MEMORANDUM

To: Kirkland Hearing Examiner
From: Tony Leavitt, Senior Planner
Jon Regala, Planning Supervisor
Date: June 10, 2020
File: DRV18-00312
Subject: **APPEAL OF DESIGN REVIEW BOARD DECISION
CONTINENTAL DIVIDE MIXED USE PROJECT
FILE NO. DRV18-00312**

ITEM 2 | SITE PLAN - LIGHTING

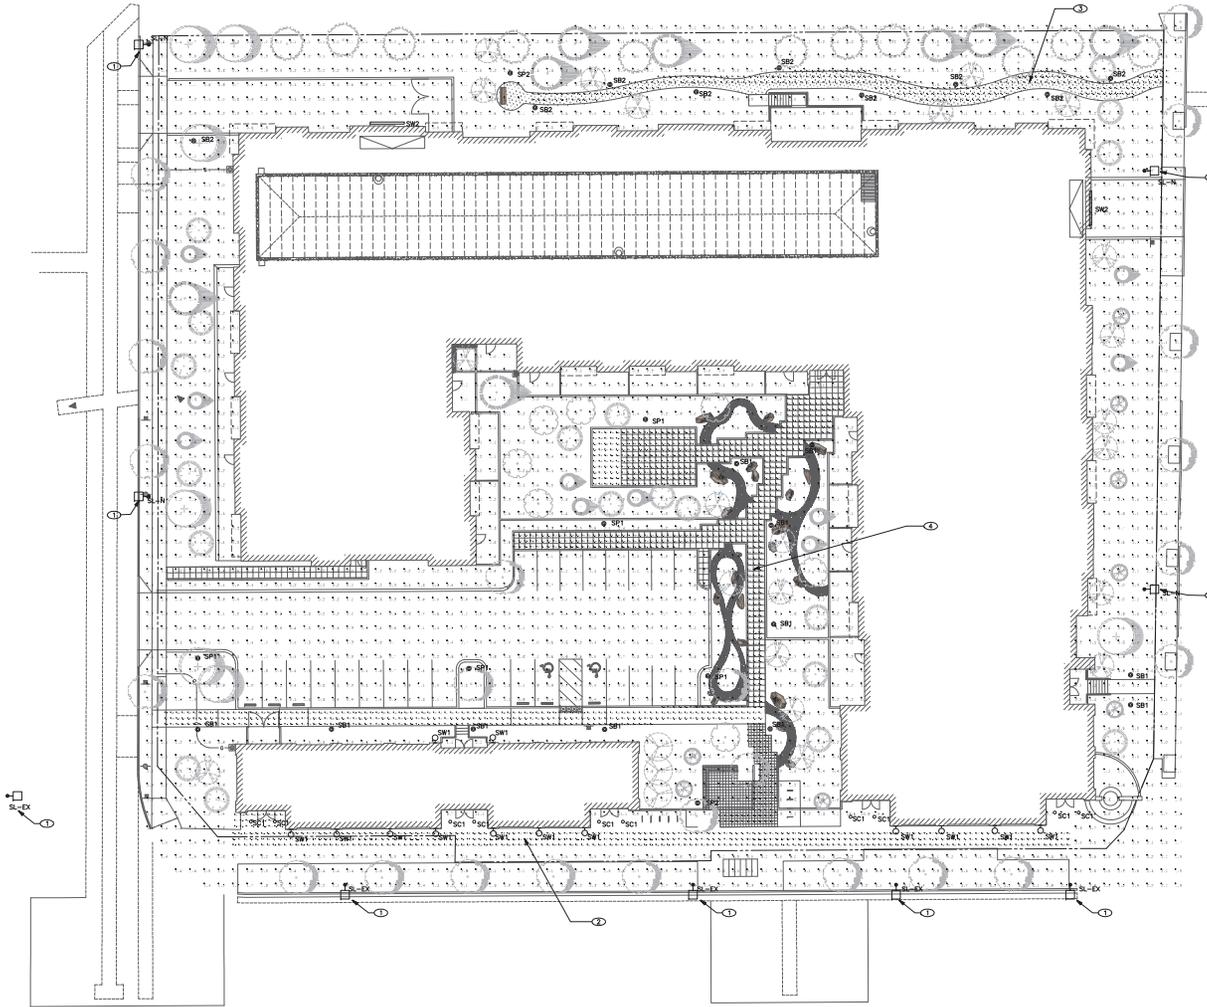
- Submit an updated formal setback modification request. The request should address the criteria in KZC Section 142.37.
- Submit a lighting plan that addresses the Design Guidelines contained in Section 9 - Lighting.

Plan at Corner of NE 85th St. & 132nd Ave. NE

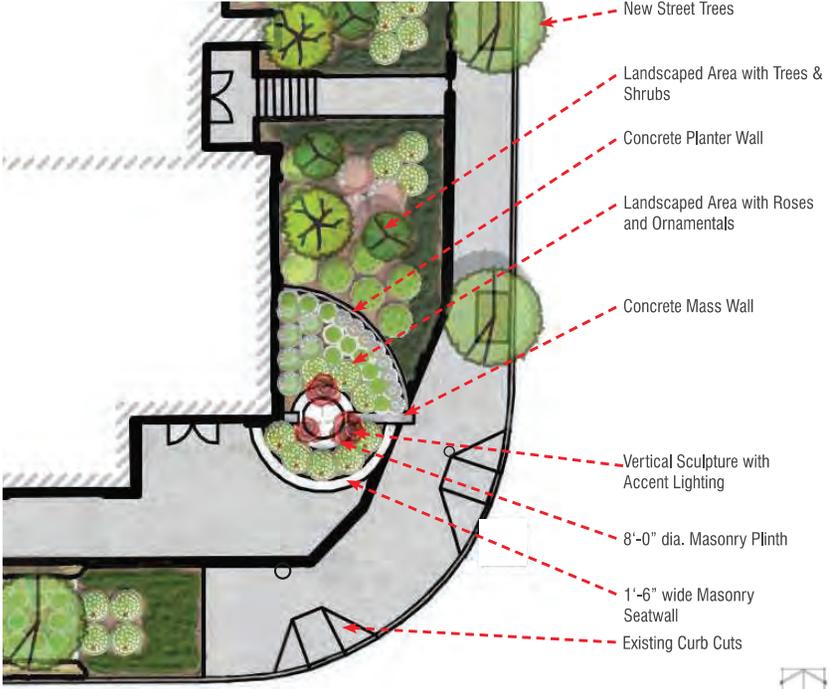
- i. The RHBD Guidelines call for a unique landscaping treatment at the gateway corners of Rose Hill (DG 1A). No discernible “distinctive landscaping with a rose garden or other distinctive soft-scape elements are visible. No detailed design of the gateway landscape feature is presented (even though detailed plans of the plaza are shown).”

- v. In direct opposition to the guidance, no lighting is proposed at the corner to illuminate a gateway element or provide “decorative lighting elements” (DG-1E).

with a rose garden or other distinctive soft-scape elements are visible. No detailed design of the gateway landscape feature is presented (even though detailed plans of the plaza are shown).

DG-1e – In direct opposition to the guidance, no lighting is proposed at the corner to illuminate a gateway element or provide “decorative lighting elements.”

- ii. An applicant is not required to incorporate all of the above-listed features. Here, the applicant proposed a gateway feature that included the planting of rose bushes with a multicolored masonry raised planter bed with artwork in the form of a large climbing rose sculpture with accent lighting (see Enclosure 2, Attachment 2, Page 21). The Design Review Board properly concluded that the proposed design met the design guideline requirements.

Partial Elevation - 132nd Ave NE

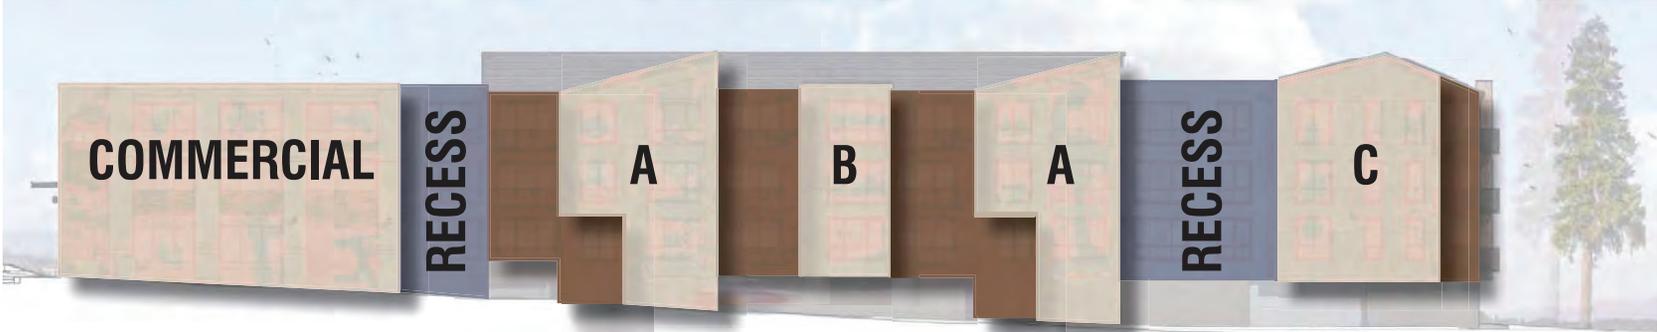
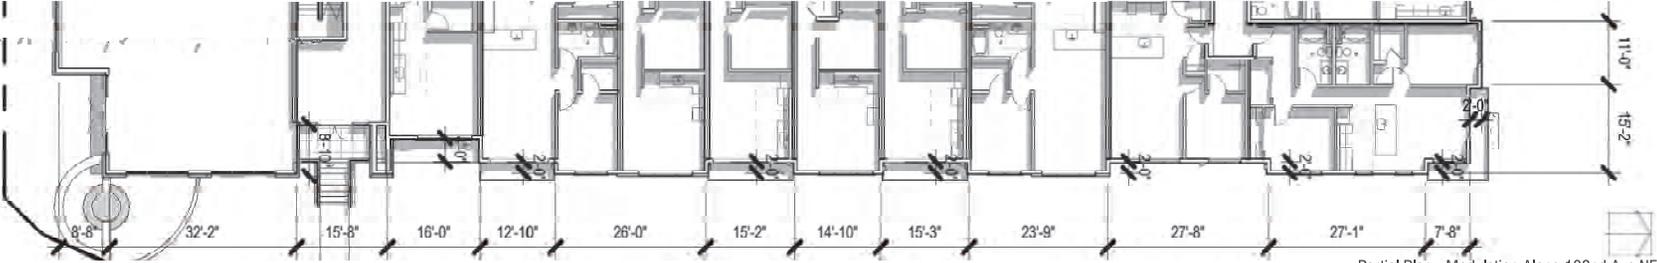
After review of the plans and listening to public comments, the DRB was concerned about the visual impacts of the north and east façades. They requested that the applicant increase the amount of vertical and horizontal modulation along these facades, decrease the number of windows and balconies along the north façade and treatment of the parking garage along NE 132nd Street. Additionally, the DRB emphasized the importance of the entry gateway feature and the design of the highly visible NE 85th Street and 132nd Avenue NE street corner. Over the next three meetings, the DRB provided feedback on the applicant's responses to the Board's direction.

APPENDIX | TREE PLAN

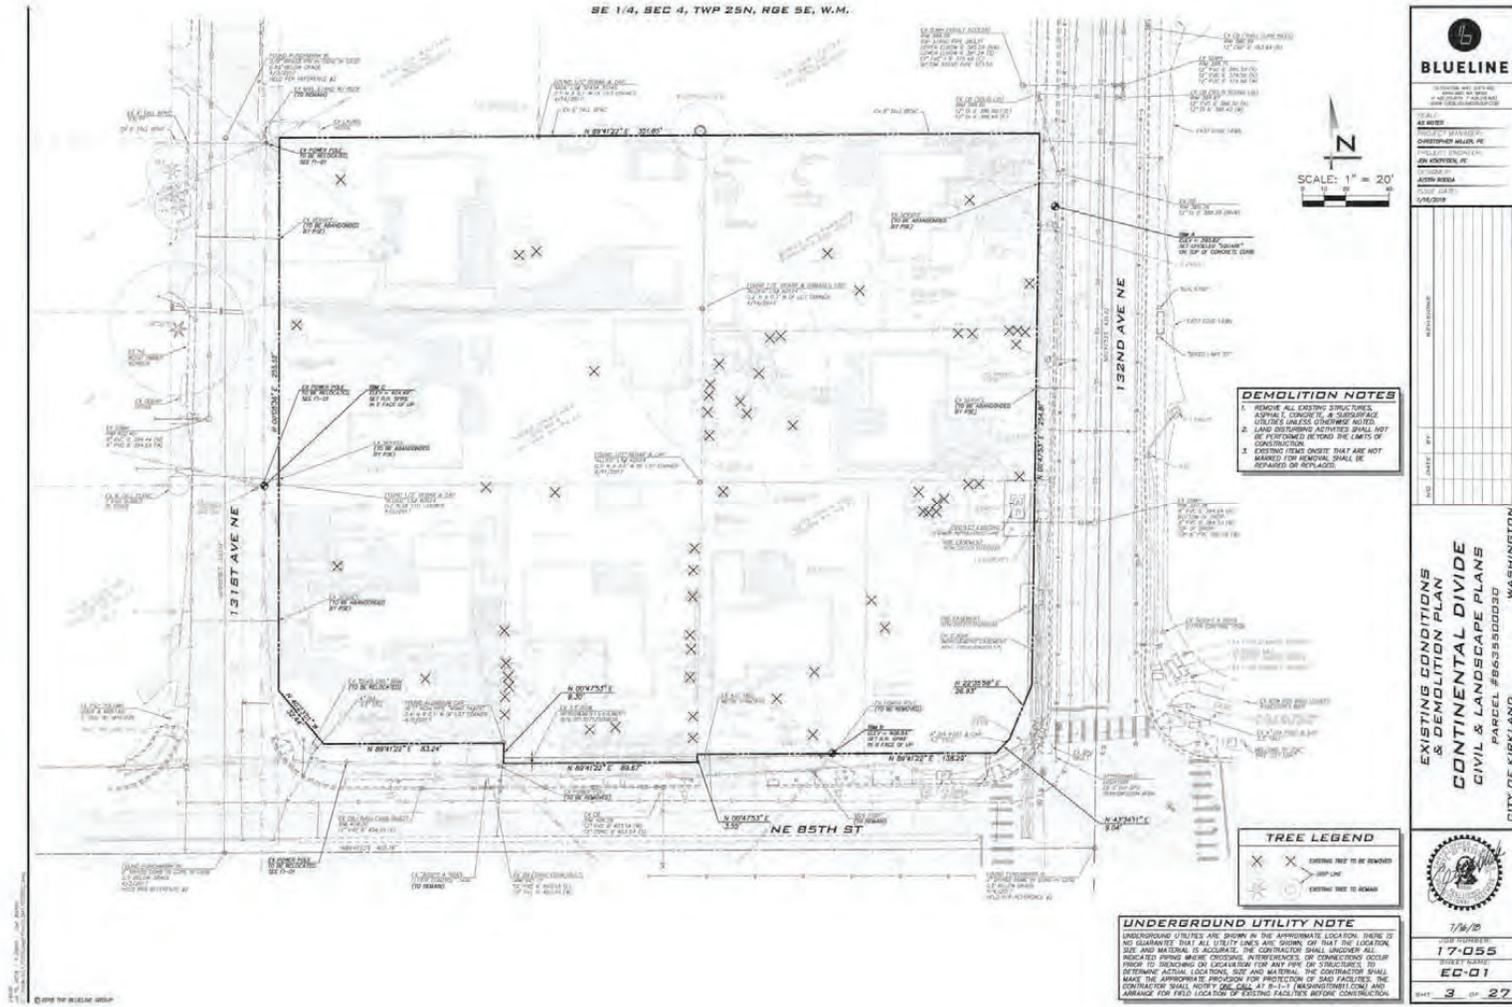
- i. DG-2A: The street trees required by Section 2 of the design guidelines are not documented properly, especially on 132nd where the red trees are shown in the middle of a sidewalk and, therefore could not be planted.
- ii. DG-2B: The trees do not represent a “unifying element.” The red trees shown on the plans are not specifically called out and do not relate to the example trees shown elsewhere in the applicant’s submittal to the DRB.

- a. **Appellant:** Along 132nd, there is no “curb zone” as required by DG-6A and DG-6B. In addition, trees are shown planted in the middle of the sidewalk, which is not consistent with their use as a sidewalk.
- b. **Staff Response:** The proposal includes street trees planted in tree wells along the eastern edge of the sidewalk adjacent to 132nd Avenue NE, which meets the curb zone requirement of this guideline (see Enclosure 2, Attachment 2, Page 9). The proposed design is consistent with adopted Public Works sidewalk design requirements for minor arterials.

DG-2a – The street trees required by Section 2 of the design guidelines are not documented properly, especially on 132nd where the red trees are shown in the middle of sidewalk and, therefore, could not be planted.

DG-2b – The trees do not represent a “unifying element.” The red trees shown on the plans are not specially called out and do not relate to the example trees shown elsewhere in the applicant’s submittal to the DRB.

- i. The street tree design guideline requires the project to “incorporate street trees, along all street, internal access roads and pathways” and to “encourage development to utilize street trees as a unifying feature of the development”.
- ii. The DRB approved plans call for the planting of maple trees along all three frontages (see Enclosure 2, Attachment 2, Page 60). Staff reviewed the building permit plans and the trees will all be Armstrong Maples. The trees along 132nd Avenue NE are located in tree wells pursuant to Public Works standards. The tree wells are located along the eastern edge of the sidewalk and not in the middle of the sidewalk. Because the frontage trees comprise one species, they represent a unified tree palette within the project.
